SALES BULLETIN

DIRECT SPARK IGNITION WATER HEATER GAS VALVE AND BURNER PART NUMBER CHANGES

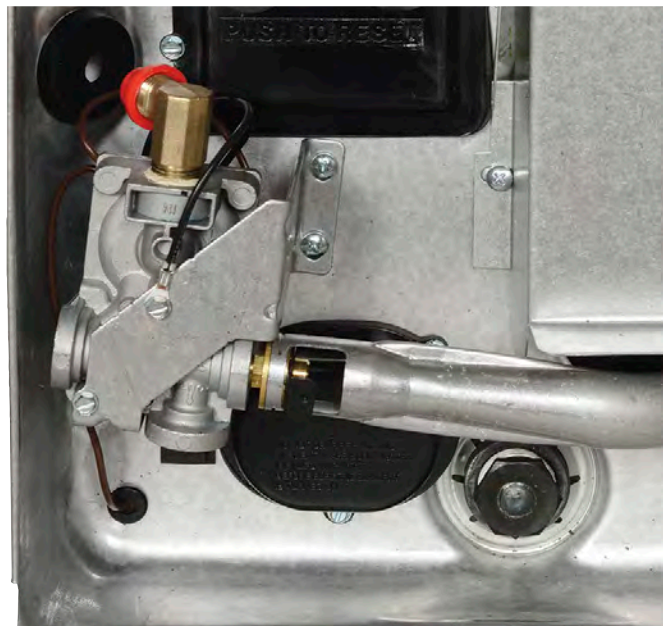
The purpose of this Sales Bulletin is to provide information concerning Suburban DSI water heaters. Based on Suburban's commitment to continuous improvement a change was made to all 12 VDC DSI water heaters. This change went into effect November 10, 2016.

PLEASE NOTE: parts listed above are not interchangeable or backward compatible with previous components. The correct part must be installed on these water heater models. To the right is a picture for identification of the changes.

DESCRIPTION	PART NUMBER
Gas Valve-3/8 NPT INLET 1/8-27 NPT OUTLET	161255
Burner Assembly	011030
Burner Orifice for 161255 Gas Valve #61 (6-10-12-16 gallon)	180323
Burner Orifice for 161255 Gas Valve #65 (4 gallon)	180325
Orifice Retainer Clip for 161255 Gas Valve	063827
Valve Mounting Bracket for 161255 Gas Valve	063779
